Technical Service Bulletin No. 42

Created by: Music Tribe Brands Sweden AB Service Department

Reference no: SP40PFC

SP40PFC-XXXX

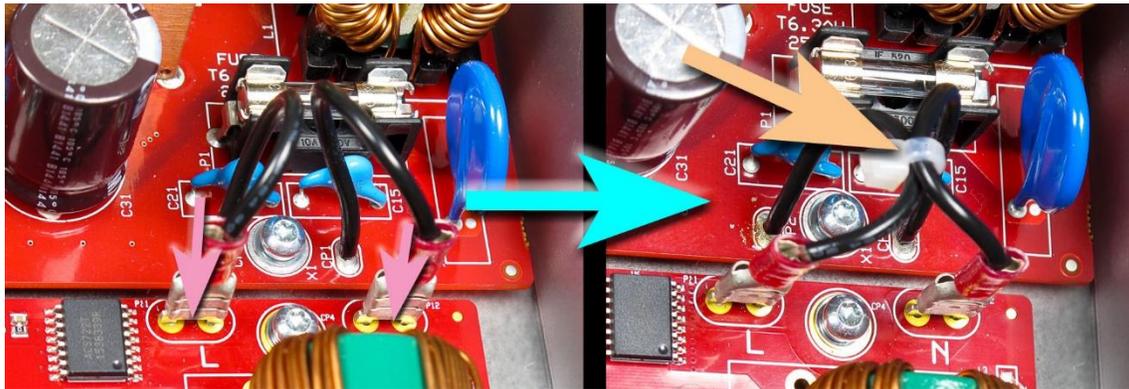
Modify the SP40PFC-XXXX adding a capacitor and a diod

If you don't have the equipment for soldering 0603 components, please replace the complete board

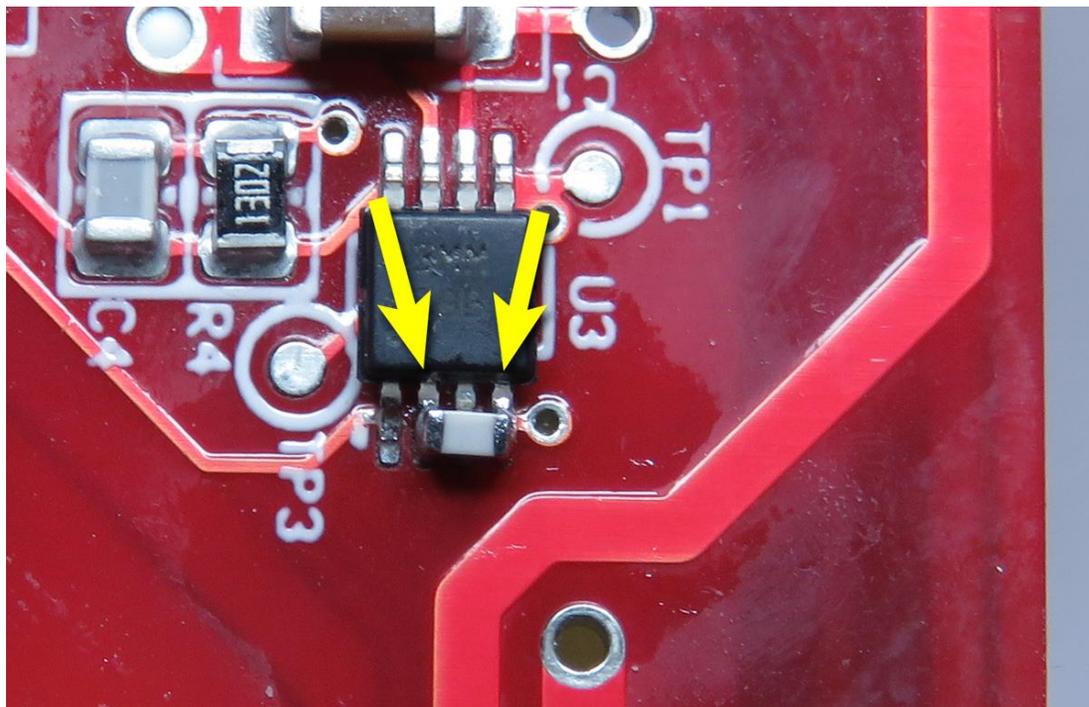
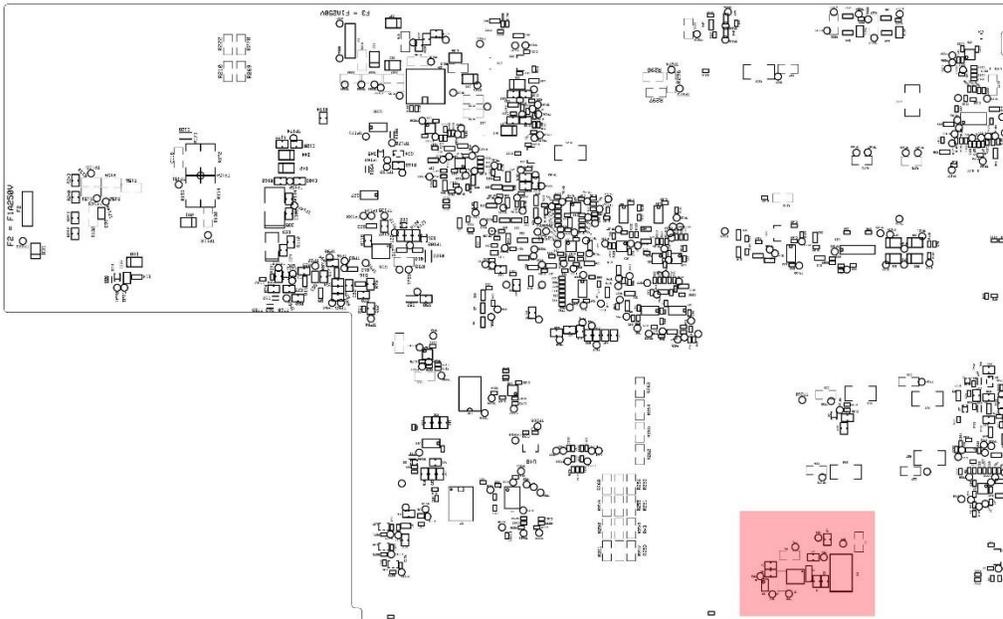
Mount capacitor (470p500603NP05%) on top of component between legs 2 & 4 on position U3.
